September 29, 2005
E910-05-068

Subject: Saxton Nuclear Experimental Corporation
Operating License No. DPR-4
Docket 50-146

Response to Additional Comments on SNEC Final Status Survey Reports

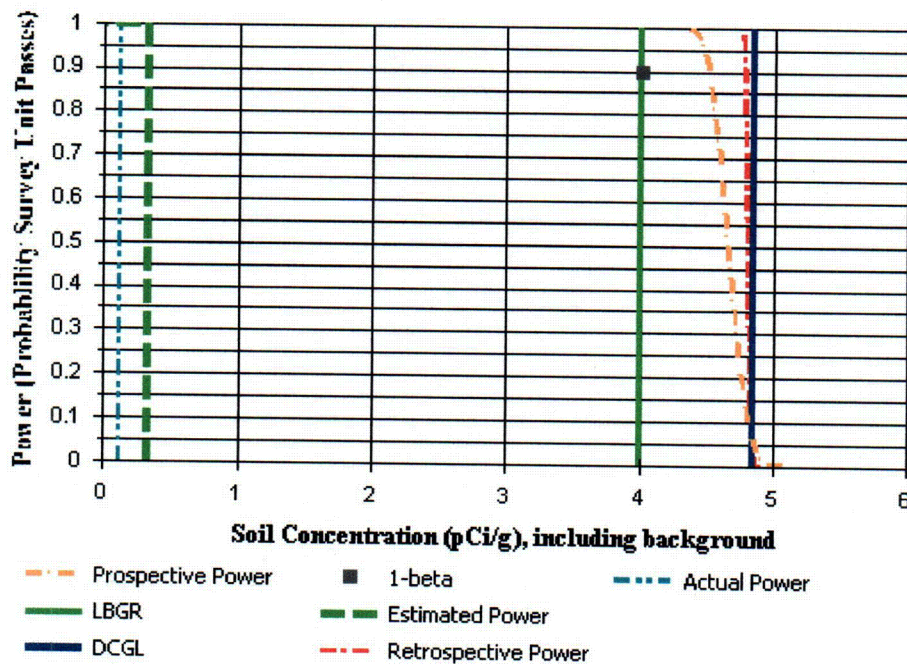
2) A page was missing from the appendix. The two pages of the COMPASS soil report for OL13-3 are provided below to replace the first page and provide the missing page of Appendix D.

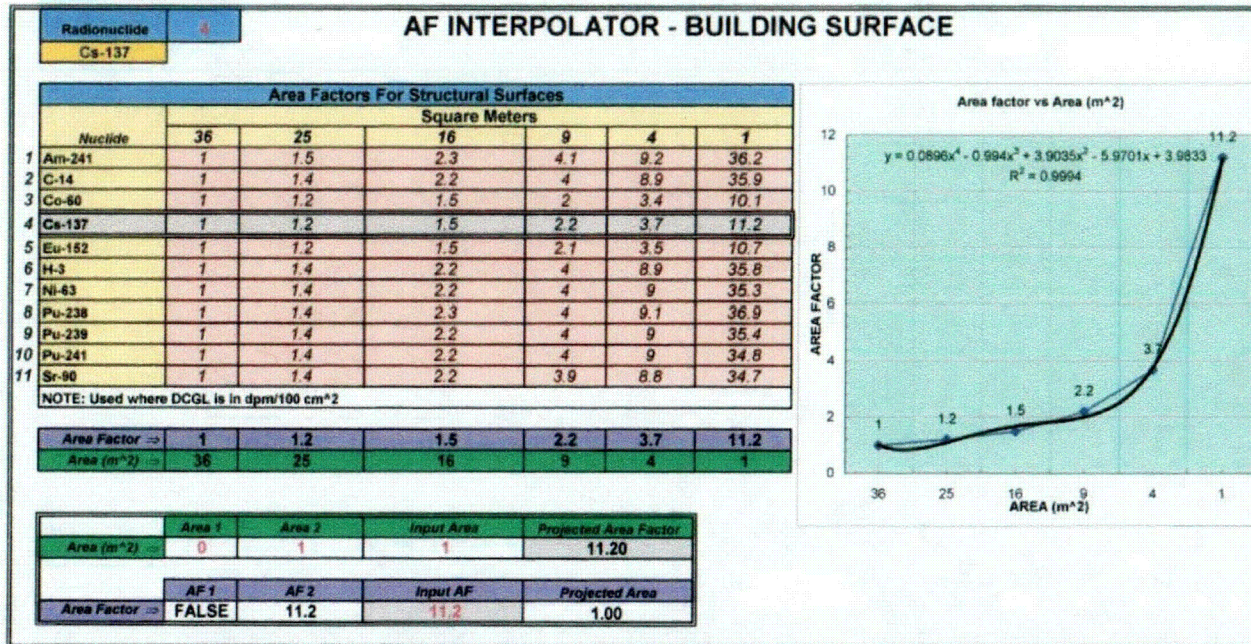
8) Different cases may involve calculations of gamma flux in different models.

Microshield calculations are then repeated in order to provide appropriate conversion factors. Engineering judgment is used in all of these cases to develop appropriate model conditions. In this case, the difference between 11-inch radius and 11.1-inch radius produces a 1% difference in the MDCscan for the assumed source. This difference is trivial compared to the variance associated with the judgment involved in developing the models and changes in assumptions that are case –to case and then comparing that to the actual surfaces scanned. No changes to the report are needed.
